Site Inspection Report

Site: UPRR 43 PAN AM I5
04/26/2022

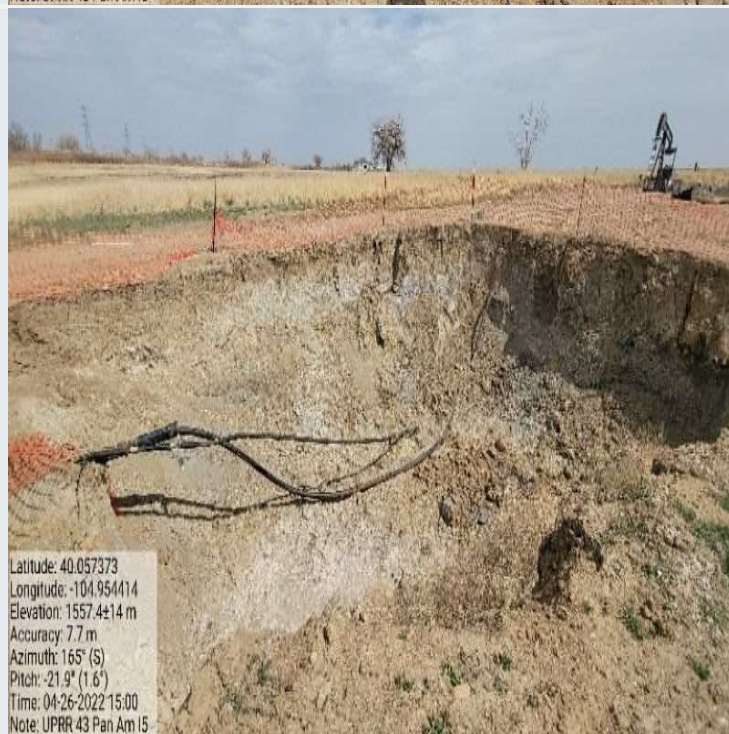
Question: Exposed buried/underground flowlines?

Response: Yes

Question: Exposed buried/underground flowlines?

Response: Yes
